City of Plymouth Planning Commission

Special Meeting Agenda

Thursday, July 17, 2025 – 7:00 p.m.
City Hall & Online Zoom Webinar

PUD 25-02: Starkweather Subdivision (behind 550 N. Holbrook), Planned unit development (PUD) amendment to allow lots 17, 18 and 19 to provide signage instead of privacy fences along the rear property lines. The property is zoned PUD, Planned Unit Development.

SITE DETAILS

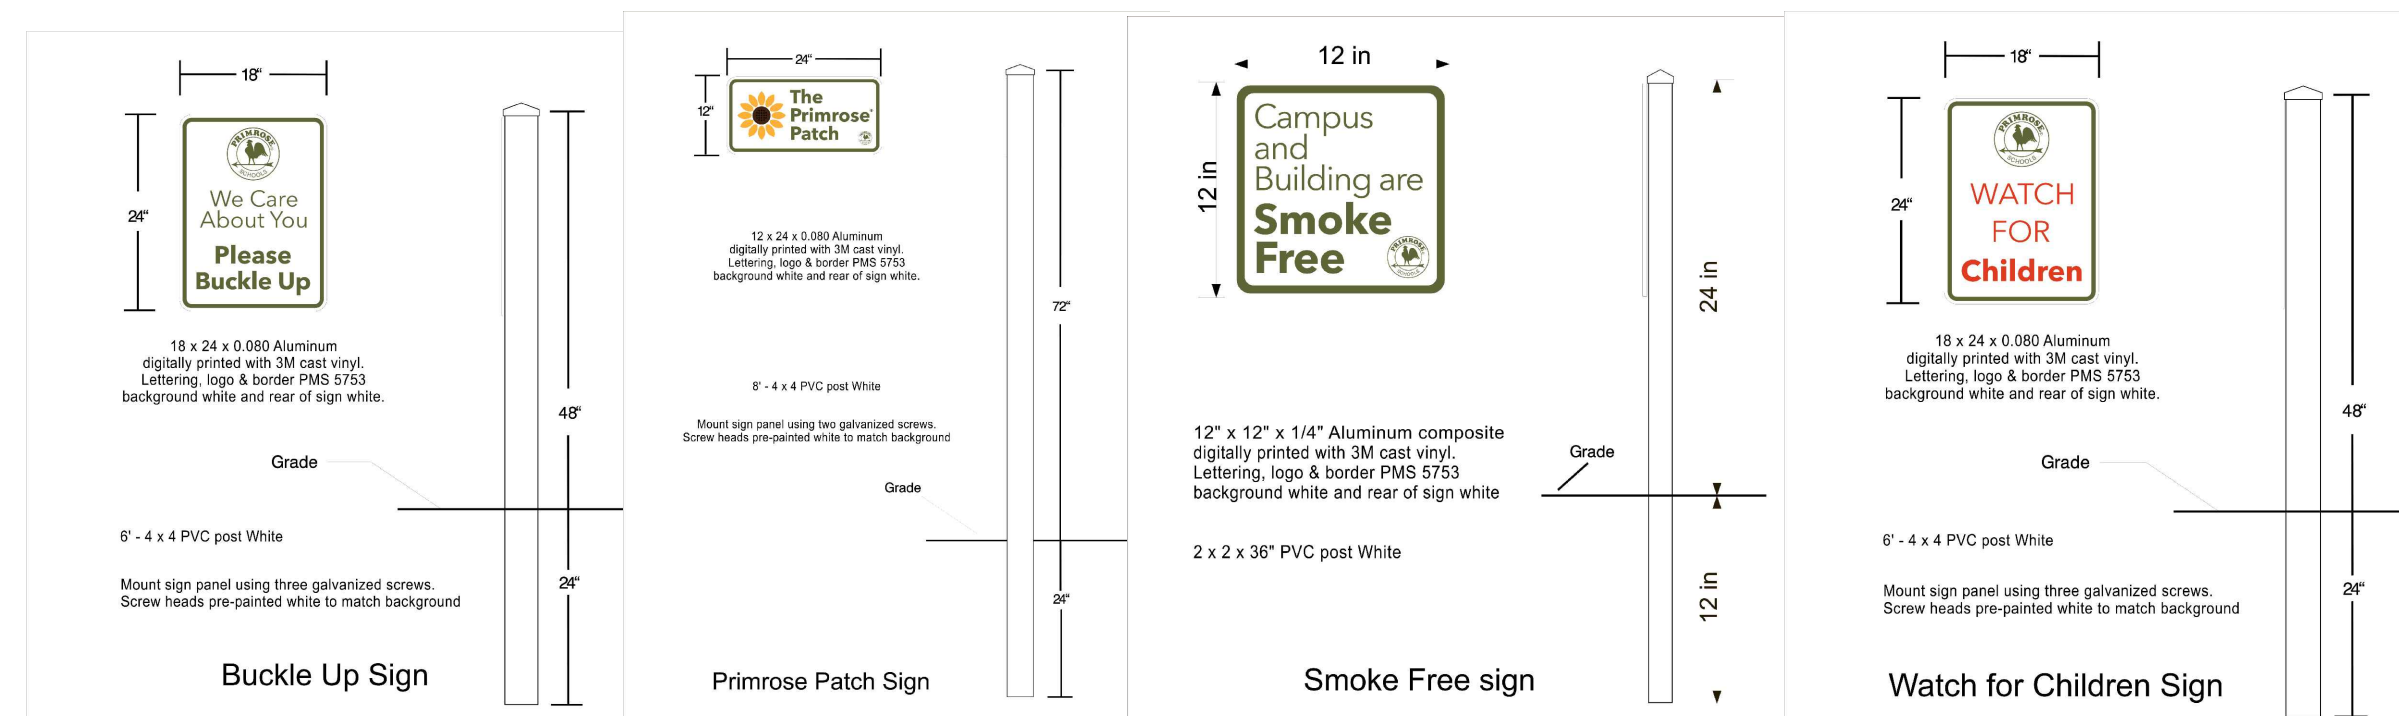
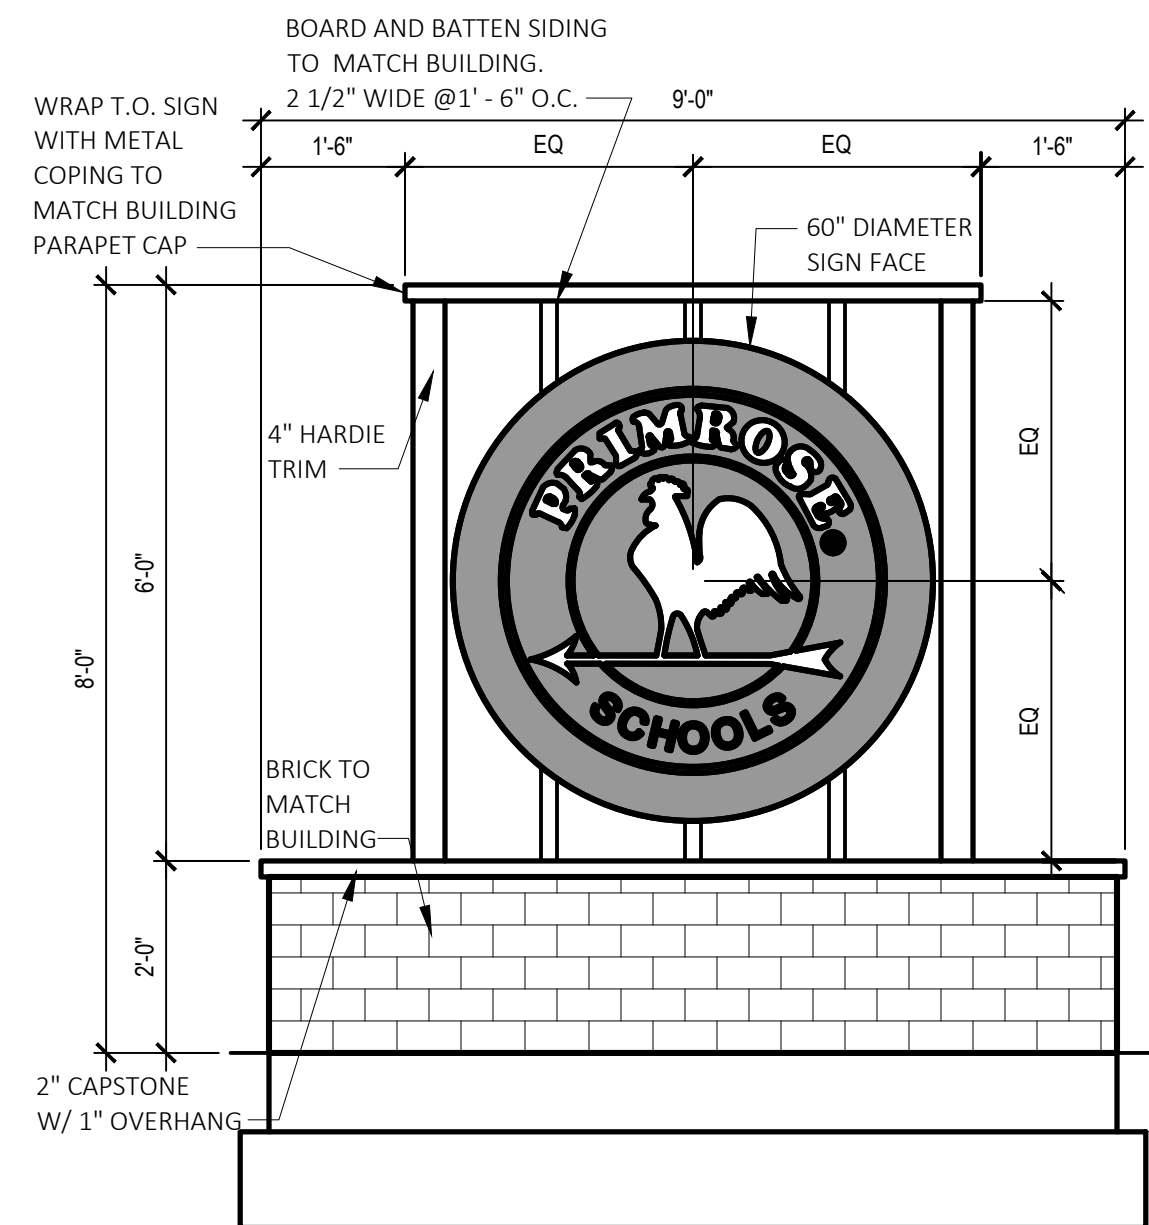
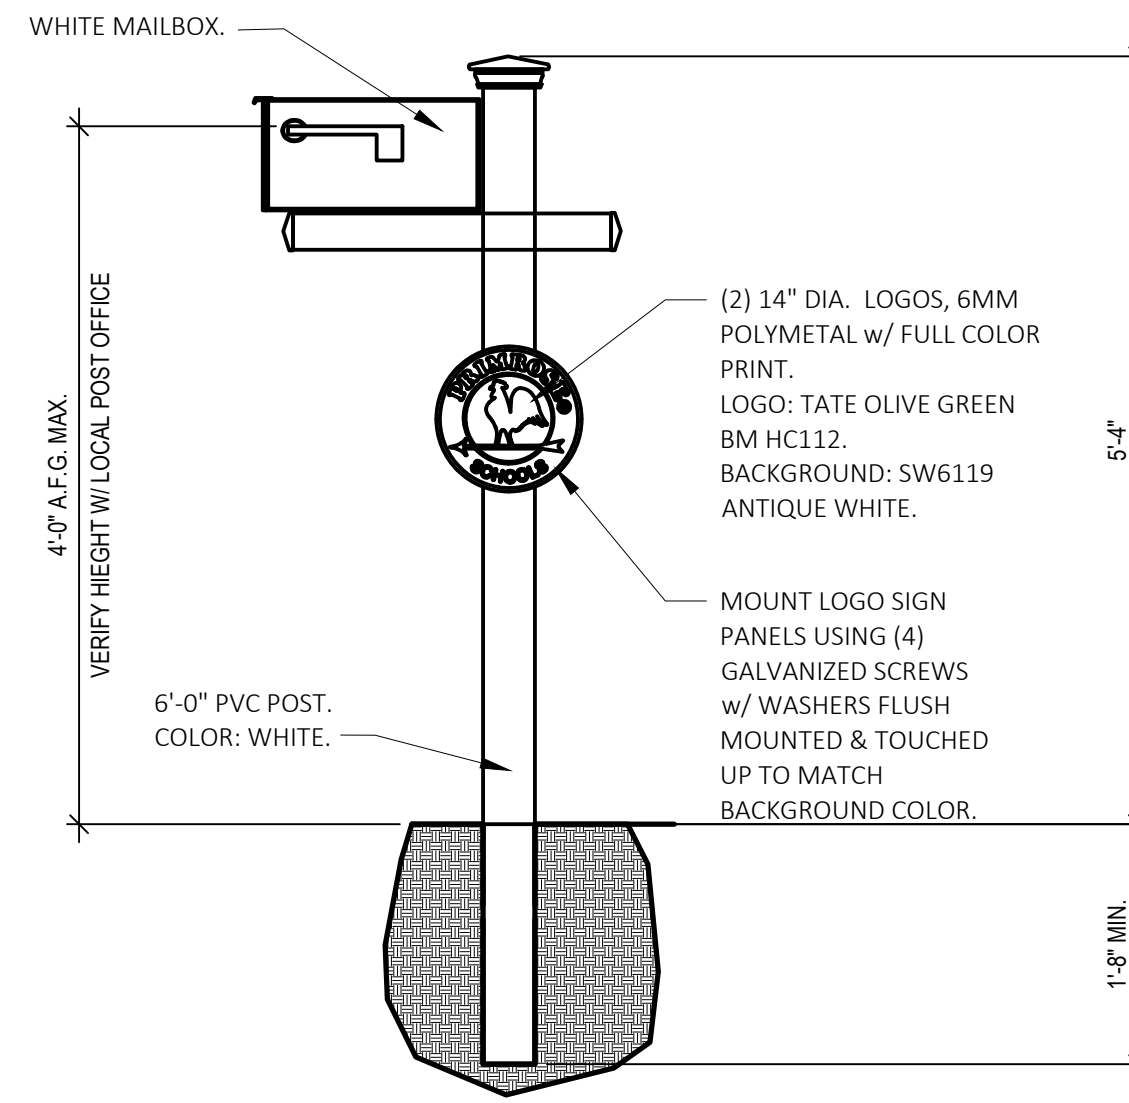
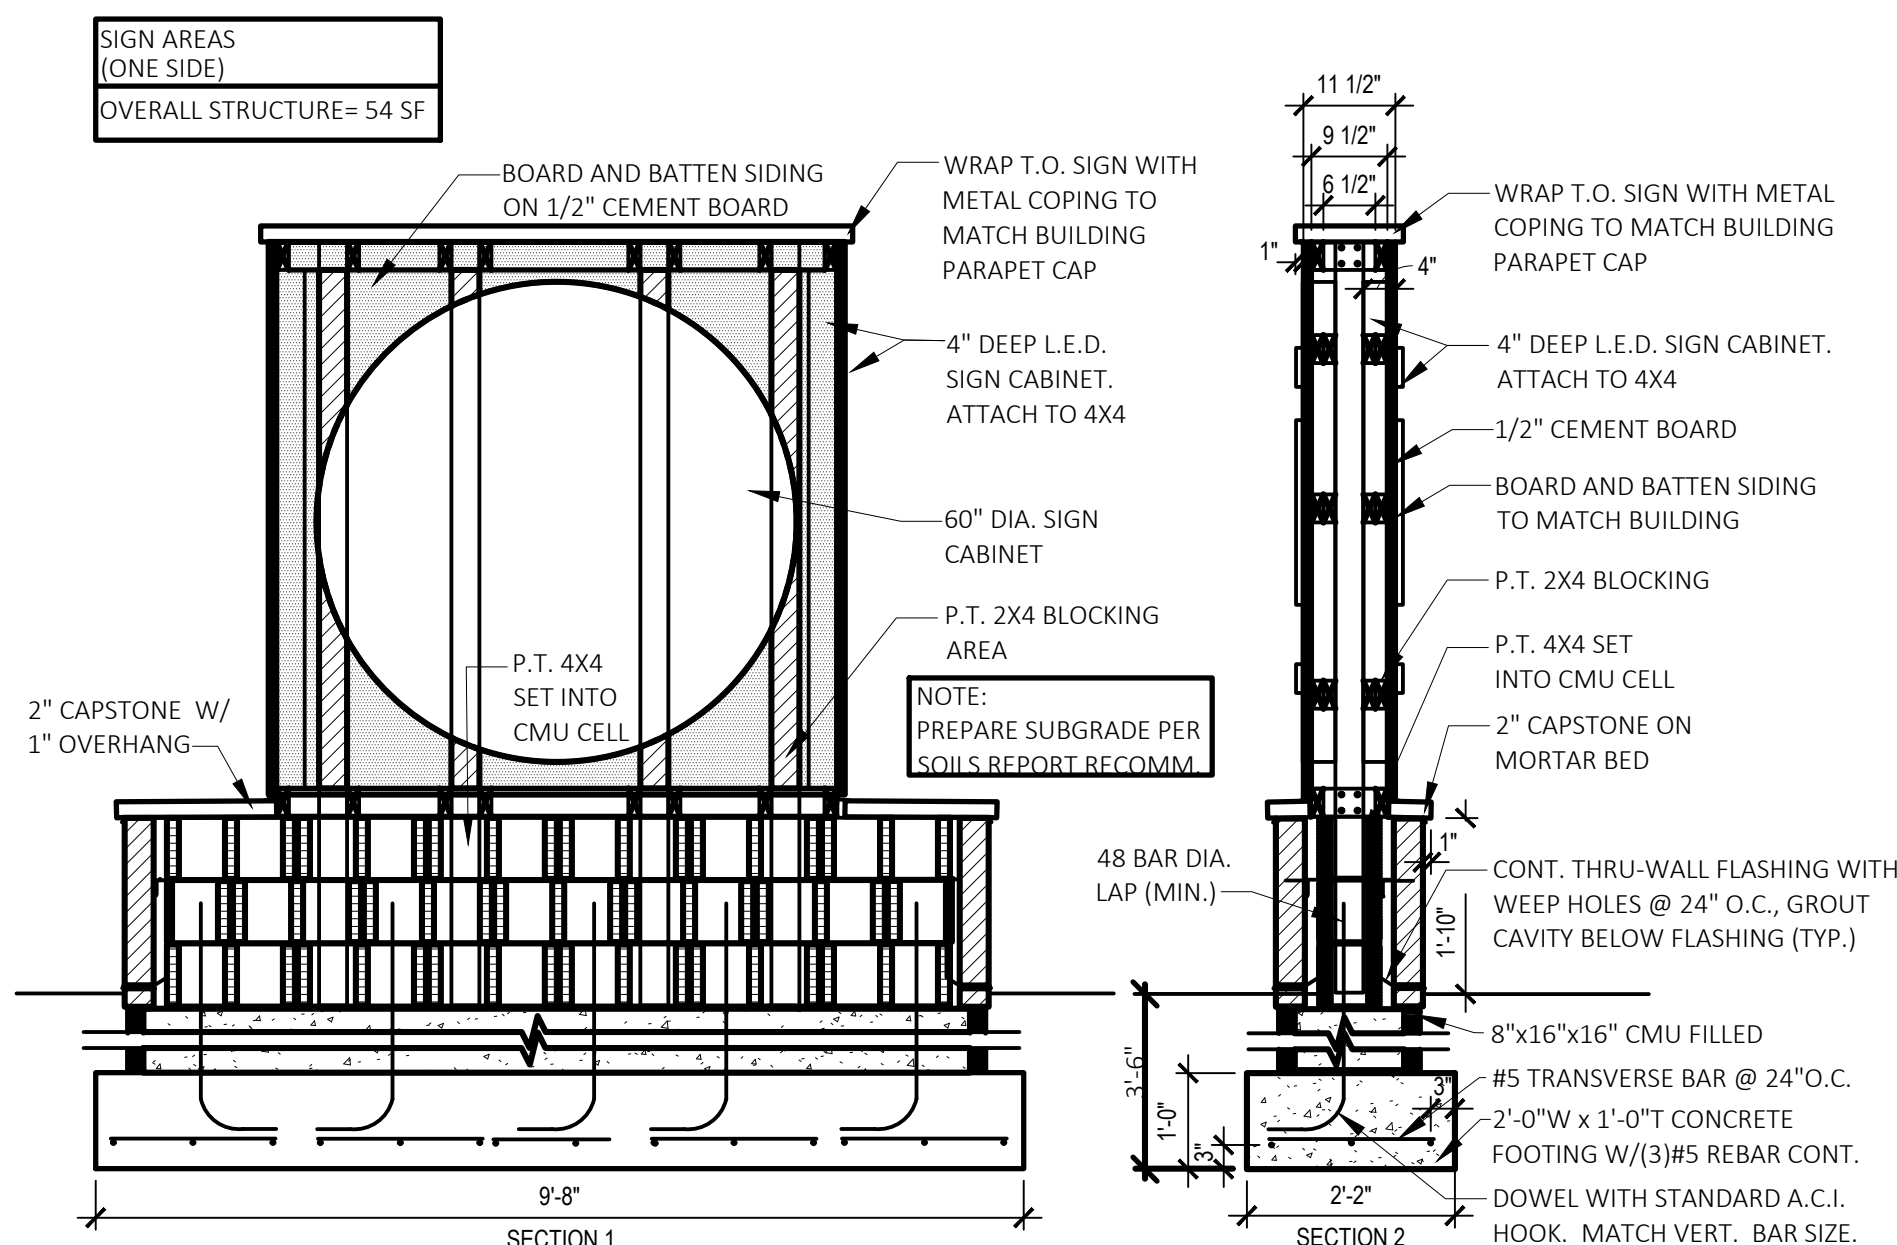
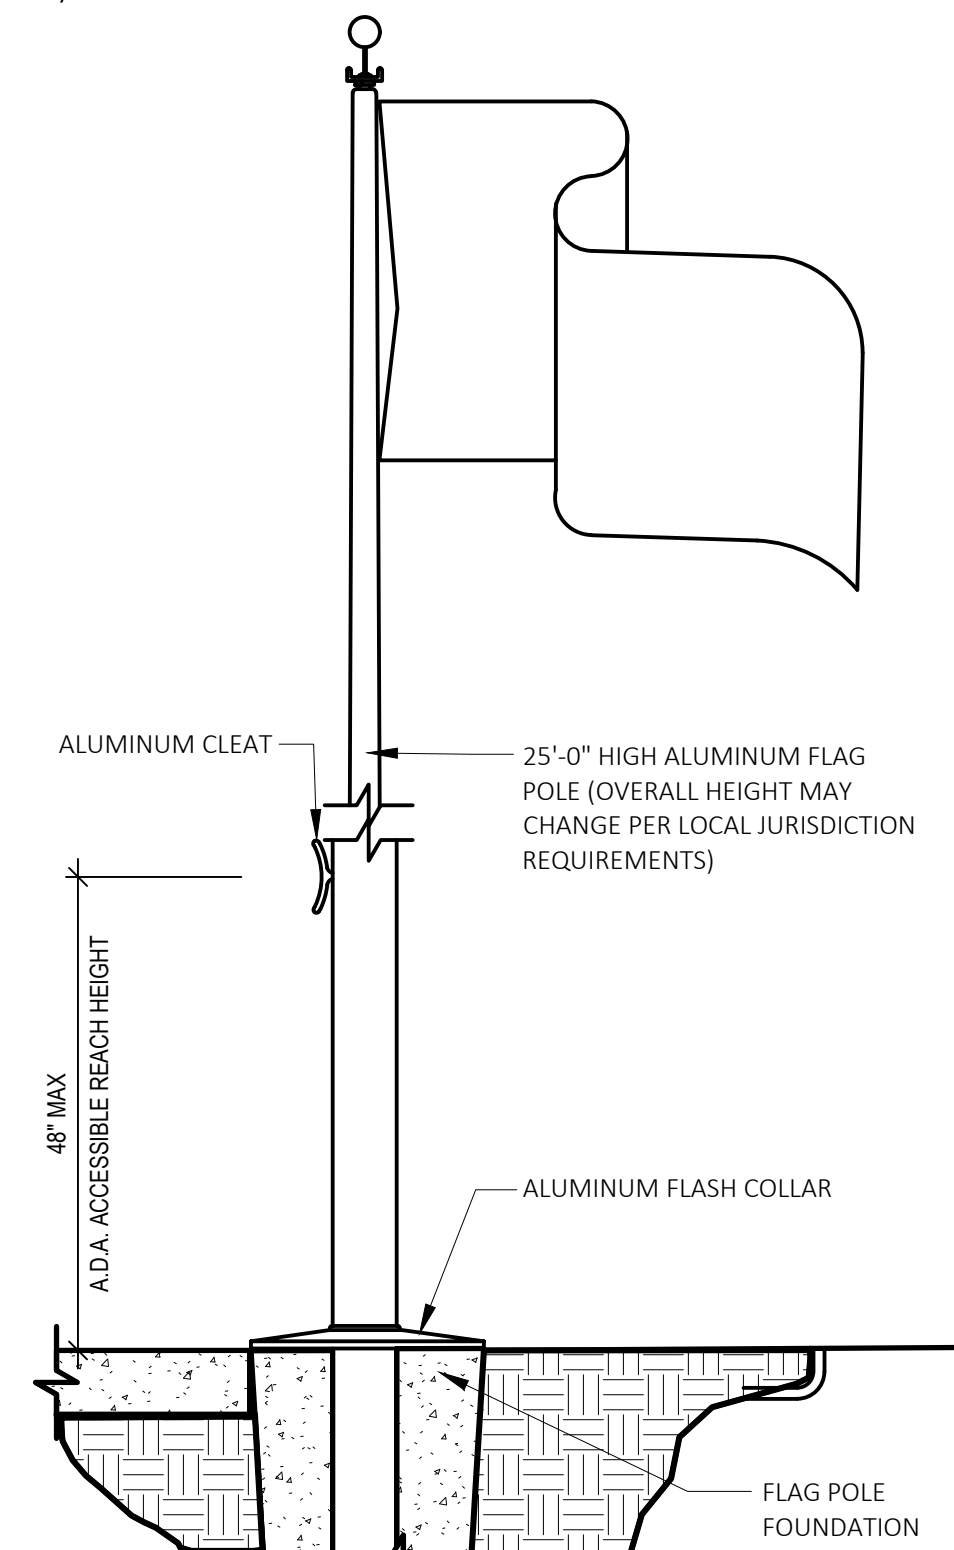
Elevations for the proposed dumpster screen are on Sheet A-5, *Site Details*, which shows the dumpster screen is seven (7') feet – four (4") inches tall. The screen is faced with a three (3') foot tall band of brick matching the building and the remaining four (4') feet – four (4") inches to be Hardie board siding in a vertical board and batten orientation. The enclosure gate is proposed to be four (4") inch ribbed 20 GA metal siding painted “Tate Olive”.

Sheet A-5.0, *Site Details*, provides proposed signage details. In addition to a flagpole, the applicant is proposing one (1) wall sign and two (2) ground signs shown in the figures below.
